January 16, 2025

ADDENDUM #4

Coastal Carolina Community College
Learning Resources Center
First Floor Renovation
SCO ID: 23-26060-01A

Sheet No. **A6.1**
 Addendum #4, Attachment #4

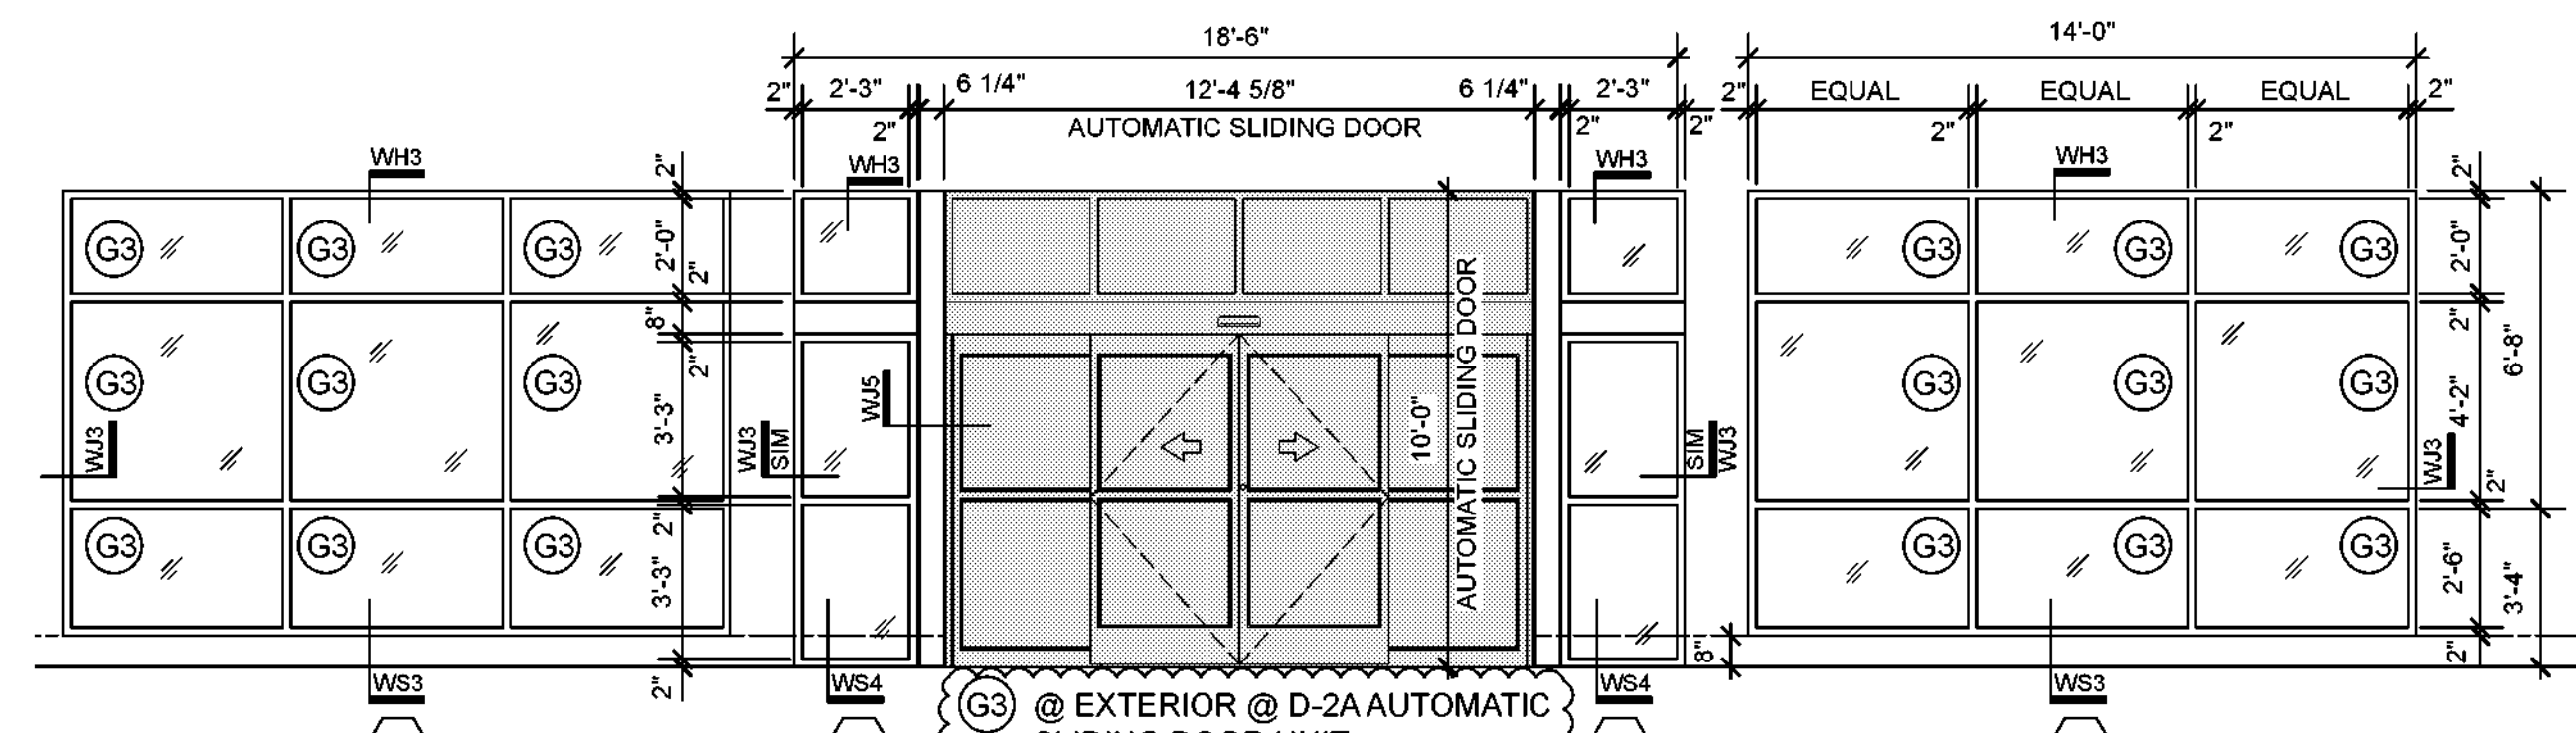
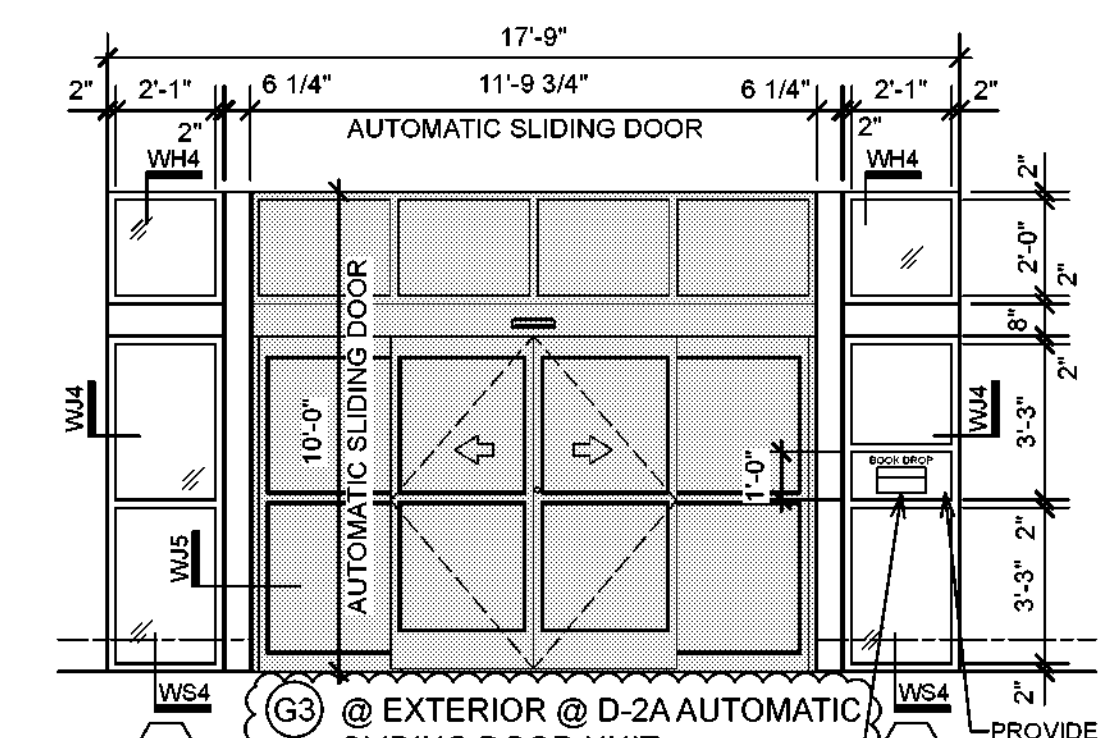
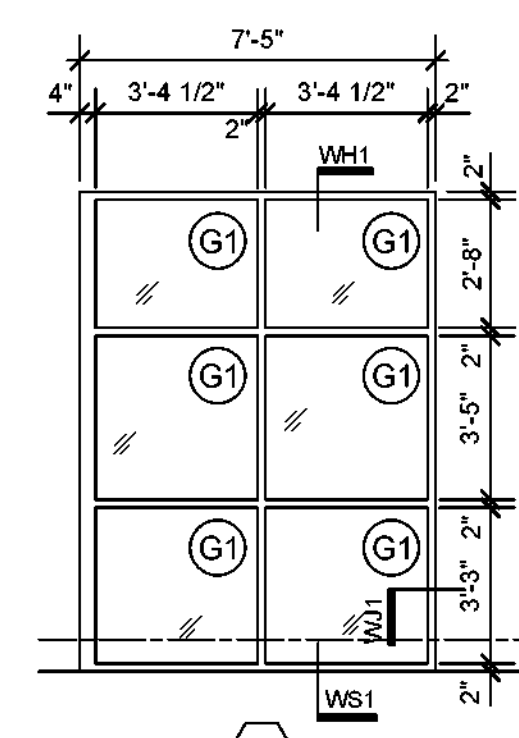
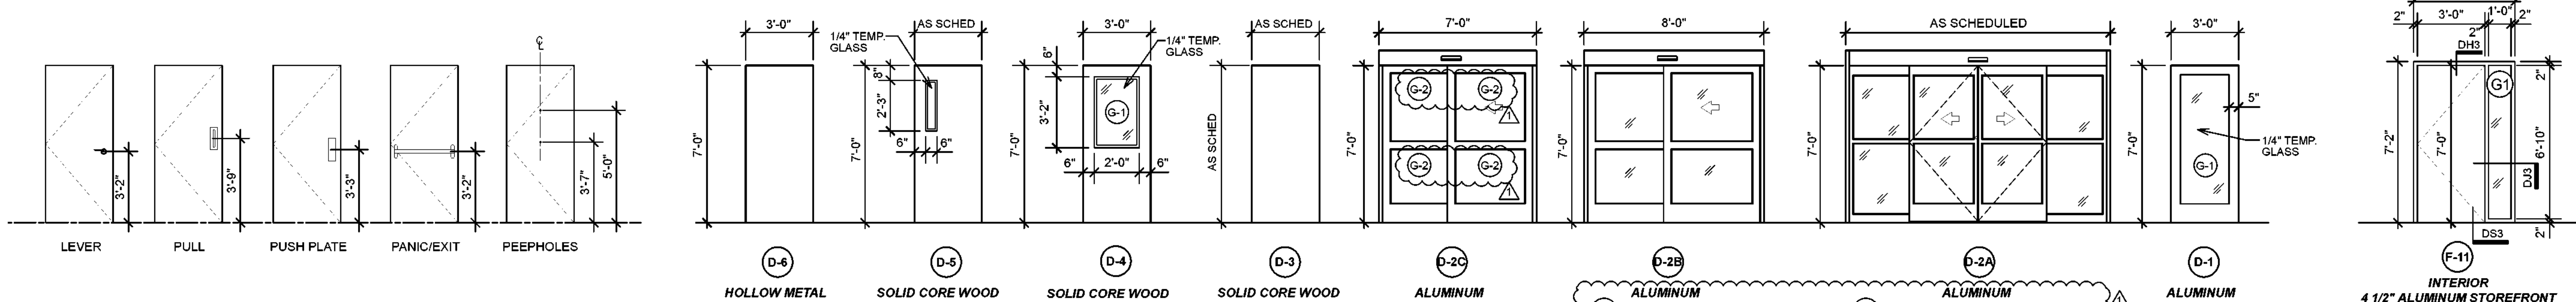
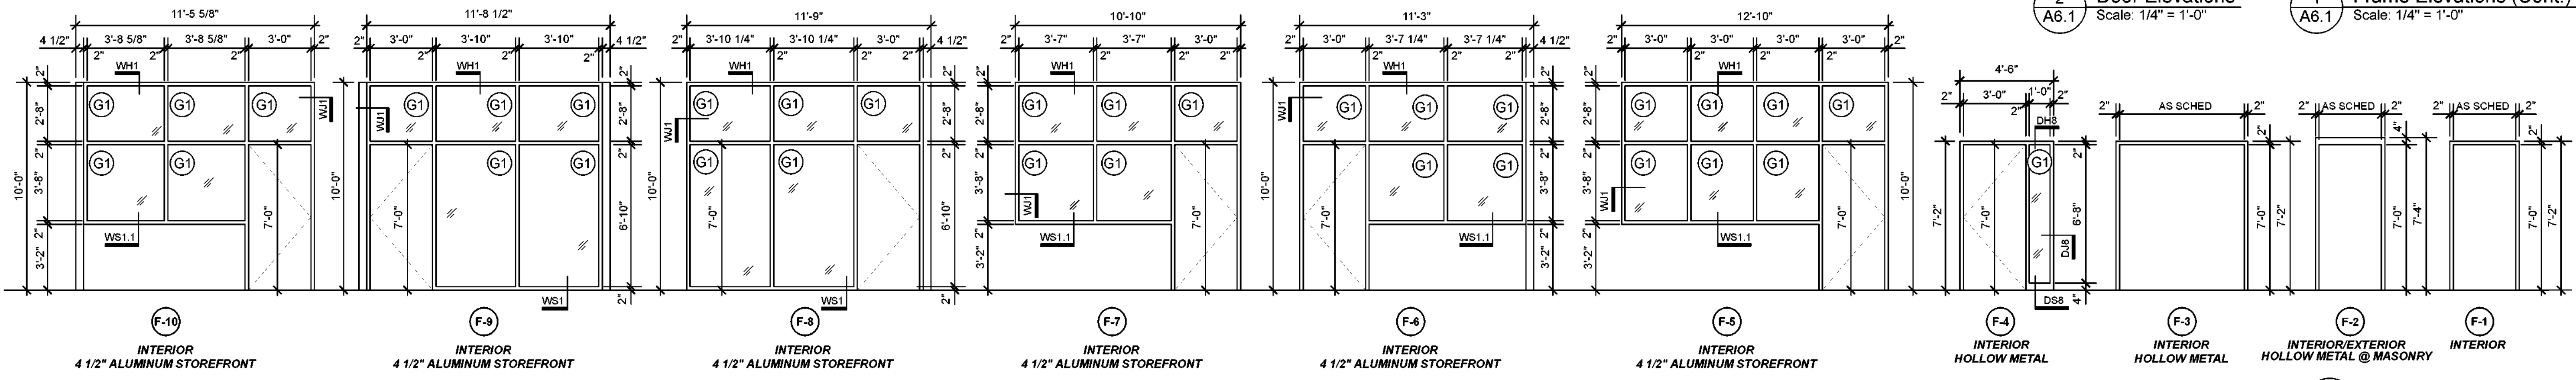
Notations have been added to clarify the glazing at the automatic sliding door units. Notations have been added to Window Elevation W-3 to clarify aluminum storefront framing requirements at this location. Revised drawing sheet A6.1 is included as **Attachment #4**.

G3 @ EXTERIOR @ D-2B AUTOMATIC SLIDING DOOR UNIT
 G2 @ INTERIOR @ D-2B AUTOMATIC SLIDING DOOR UNIT

NOTE @ W-3: PROVIDE MEDIUM WEIGHT STOREFRONT VERTICALS OR OTHER PROVISIONS AS REQUIRED BY MANUFACTURER TO RESIST WIND PRESSURES AS INDICATED ON STRUCTURAL DRAWINGS.

E1 TELECOMMUNICATION RISER DIAGRAM
 NOT TO SCALE

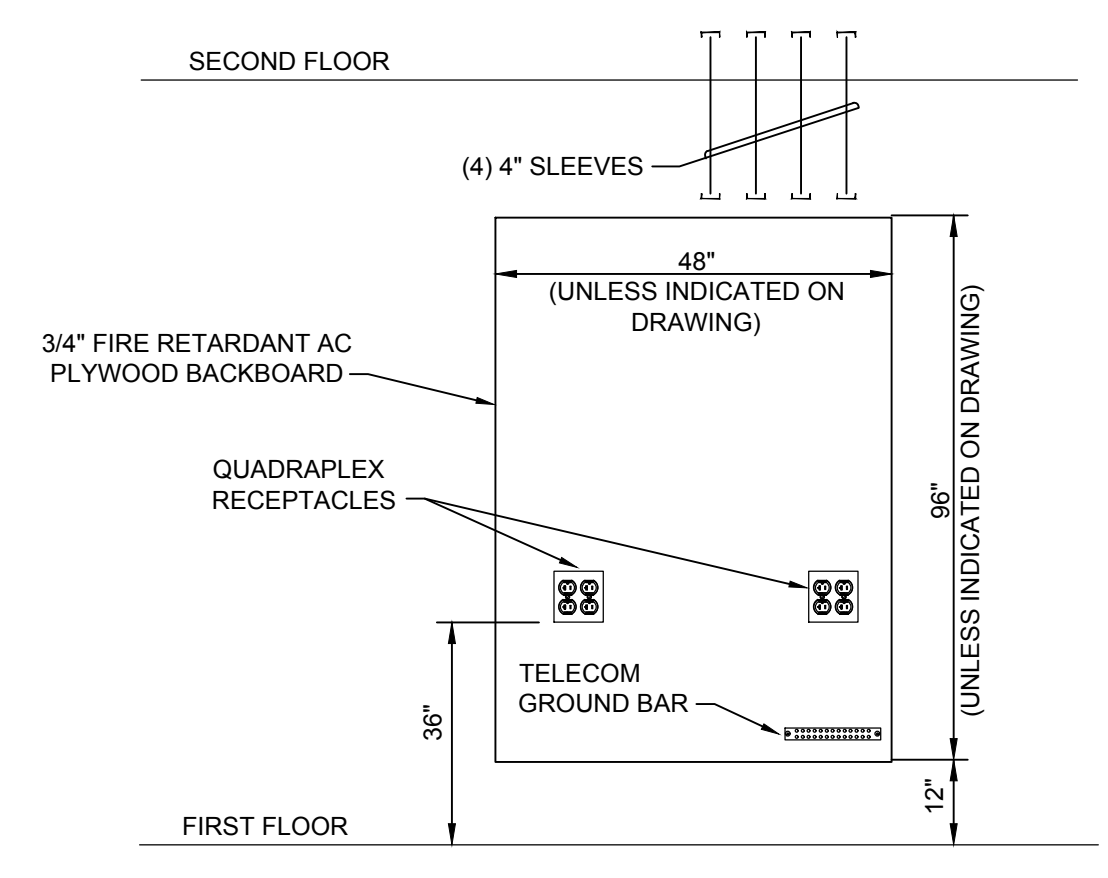
Notations have been added to drawing sheets E-0.8 and EP1.4 to protect existing backbone cabling and a fiber termination cabinet, as well as, maintain terminations at both ends (existing 2nd floor IT room and above ceiling at the location of new IT 122). Upon completion of new room IT 122 and complete installation of racks, mount existing termination cabinet in new rack. Sufficient cabling is existing to extend to new rack.
